CITY OF ALBUQUERQUE

RE: **Buddhist Temple**
Grading and Drainage Plan
Engineer's Stamp Date 11-11-16 (File: K17D112)

WAT
BUDDHASOTHORN
- VIDES
BUDDHIST
TEMPLE

GRADING PLAN

GRADING AND DRAINAGE PLAN

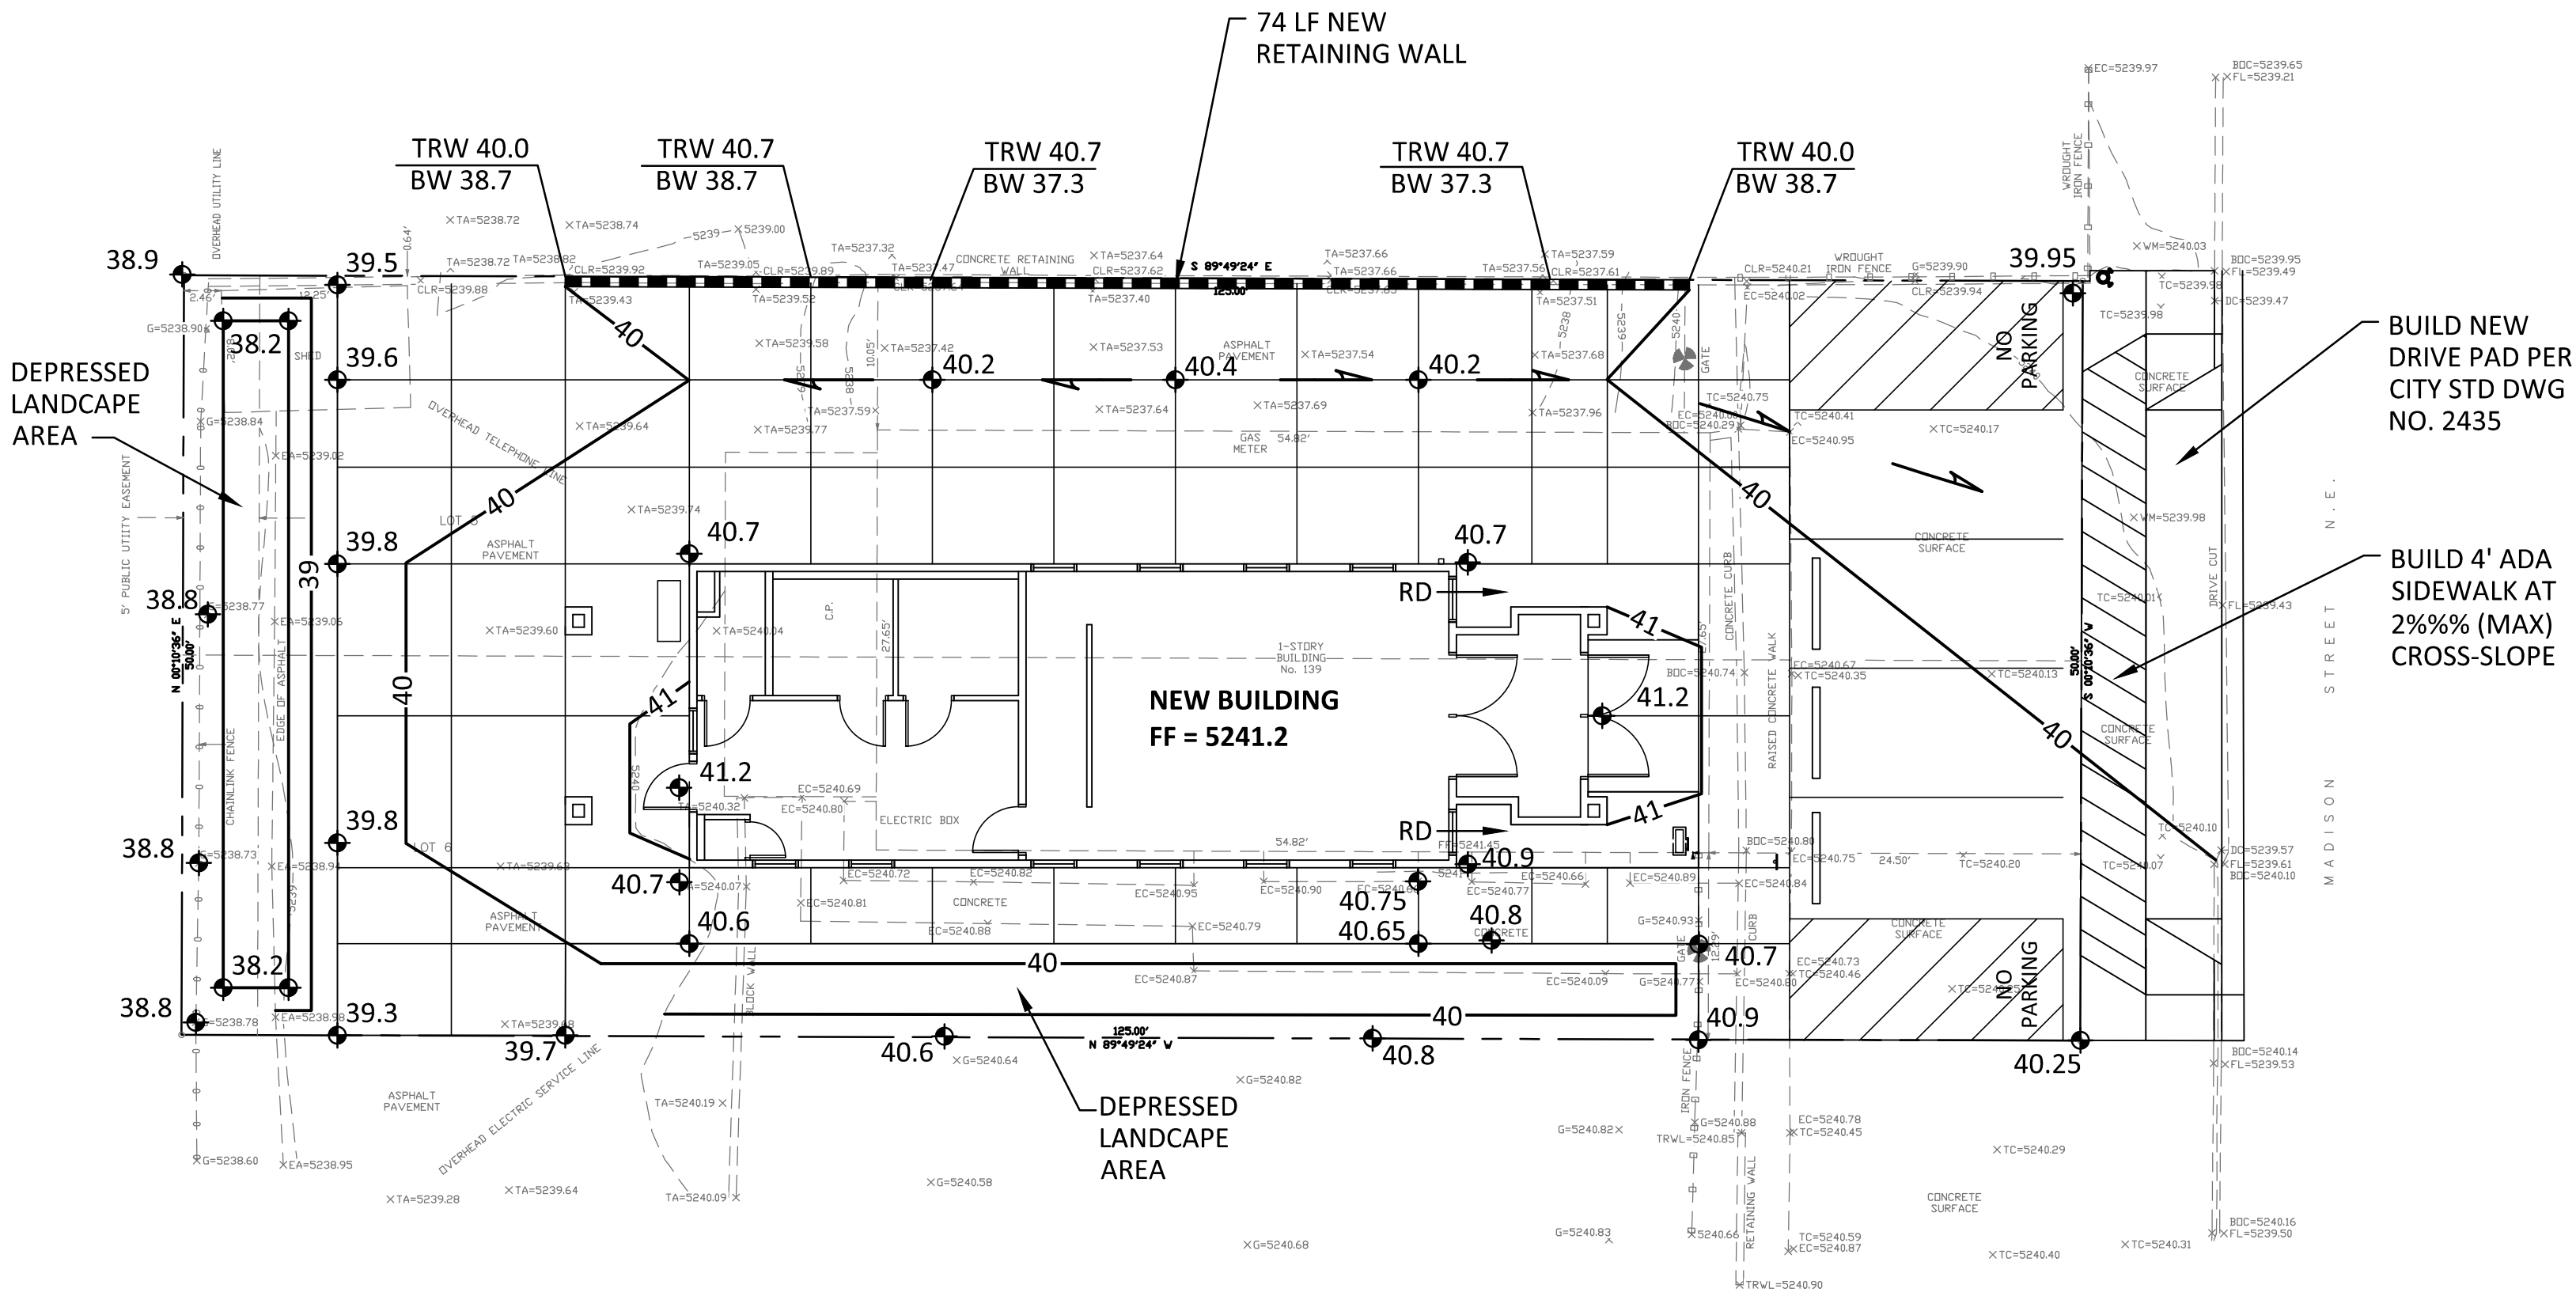
1. The Drainage Approach currently states that all flows are to be conveyed *west* to the existing drive pad. The only existing drive pad is to the *east* on Madison Street, is this the referred to drivepad?

2. As shown on the drawing, a north-south grade break roughly bisects the lot, sending some flow east towards Madison Street and some flow west towards the back of the lot. The area flowing toward the back of lot will need to be detained on-site for the 100-year, 10-day storm event. Several measures are recommended to accomplish this:

- a. A short (approximately 18" high) header wall may be placed along the back of the lot and waterproofed in order to raise the ponding depth to 5240'. This will increase ponding area and depth, while remaining at least one foot below the finished grade of the slab.

- b. The proposed depressed landscape areas may be widened, deepened and combined into one to contain a greater volume.Supporting calculations would be needed if an above option is selected. Options that would not require detaining the 100-year, 10 day storm include:

- a. Regrading the lot to convey all flows towards Madison Street. This will likely require raising the finished grade of the building slab.
 - b. A private drainage easement with the adjoining lot may be negotiated to convey flows to either Copper Avenue or Jefferson Street.

1. Provide finished grade spot elevations for bottom of depressed landscape areas.

2. Correct build note "...2%% (max) cross-slope."
3. 4x font on "Madison Street" label

Although not required, the areas labelled "no parking" may be left as crusher-fines or converted to landscaping with westward flows routed through them to decrease impervious area. If you have any questions, please contact me at 924-3695 or dpeterson@cabq.gov.
